RIVERWOOD SUBDIVISION

APPLICATION NUMBER 24 DATE October 16, 2003

DETAIL SITE PLAN

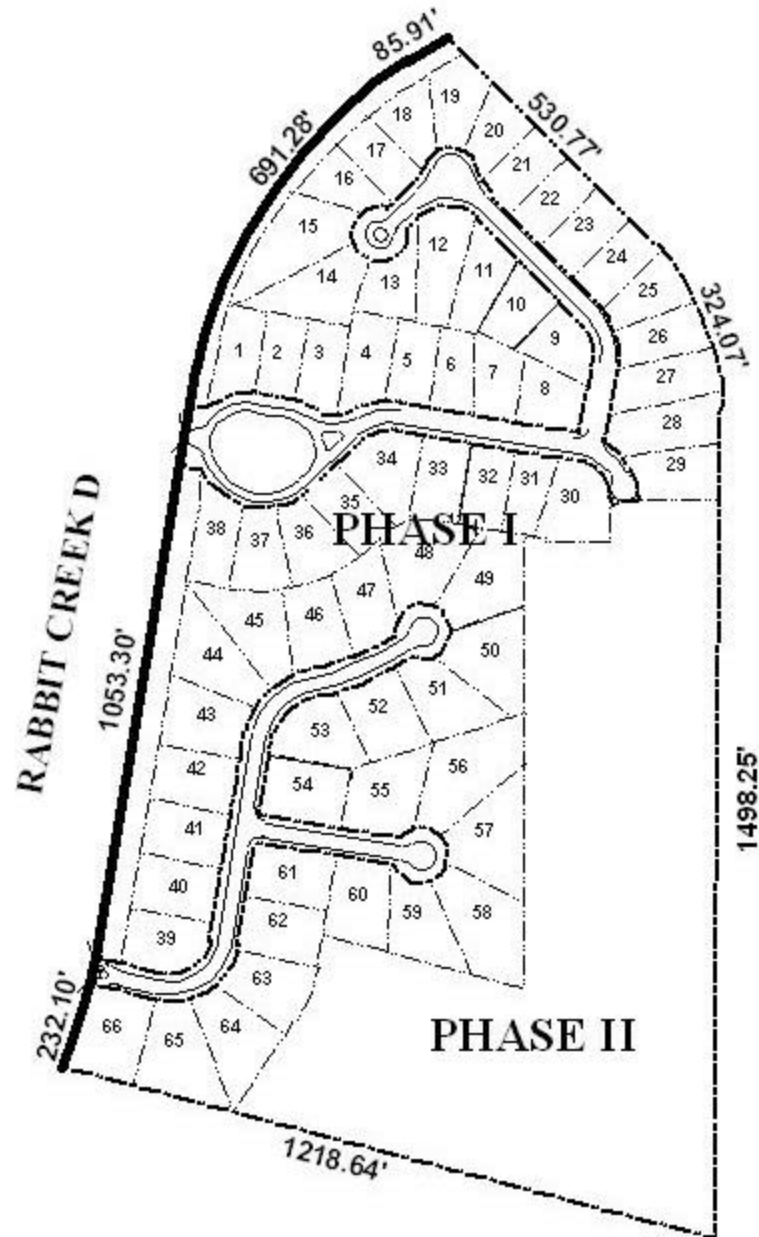
The purpose of this application is to subdivide three existing lots into 66 lots. It should be noted that Phase II as labeled on the Detail Site Plan will require subdivision approval from the commission for any development.

A note should be placed on the final plat stating that Lot 66 be denied direct access to Rabbit Creek Drive. Additionally, a note should be placed on the final plat stating that lots located on a corner (Lots 8, 28, 39, 54, 61 and 66) are allowed one curb cut each, with the design, size and location to be approved by County Engineering.

As illustrated on the preliminary plat there are several strips of property that are not identified, these strips should be labeled as common areas on the final plat, with a note stating that maintenance thereof is the responsibility of the property owners association.

The 25-foot minimum setback lines are not shown but would be required on the final plat.

With modifications, the plat meets the minimum requirements of the Subdivision Regulations and is recommended for Tentative Approval subject to the following conditions: 1) the placement of a note on the final plat stating that Lot 66 is denied access to Rabbit Creek Drive; 2) placement of a note should on the final plat stating that corner lots (8, 28, 39, 54, 61 and 66) are limited to one curb cut each, with the design, size and location to be approved by County Engineering; 3) all common areas be indicated on the final plat with a note stating that the maintenance thereof is the responsibility of the property owners association; 4) the placement of a note on the final plat stating that any lots which are developed commercially and adjoin residentially developed property must provide a buffer, in compliance with Section V.A.7. of the Subdivision Regulations; and 5) the placement of the 25-foot minimum setback lines on the final plat.
